Council Reference: DA09/0527
Your Reference: MP05_0198

Council Submission on Major Project Application (MP05_0198) for a 84 lot residential subdivision at Lot 1 DP 167380, Lot 2 DP 961928, Lot 1 DP 134787, Lot 5 DP 1117326, Walmsleys Road and Stott Street, BILAMBIL HEIGHTS

i) Right of carriageway no. 1

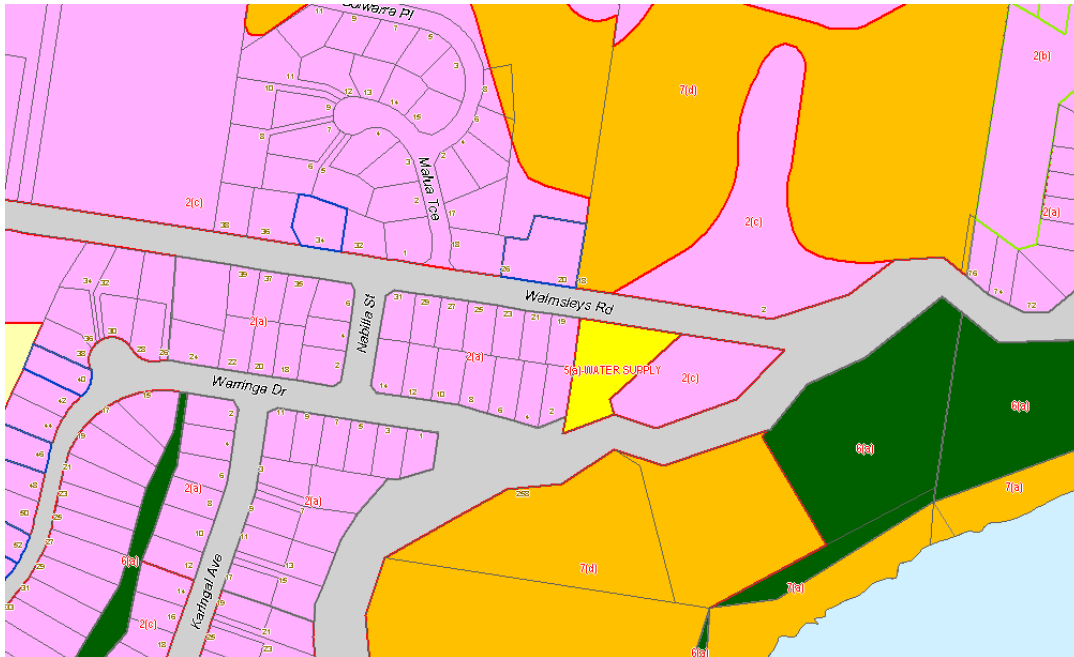
No detail has been provided for the right of carriageway serving proposed Lots 76, 77, 78, 79 and 80. A typical cross section and longitudinal section is to be provided for the proposed right of carriageway to demonstrate compliance with Council's standards.
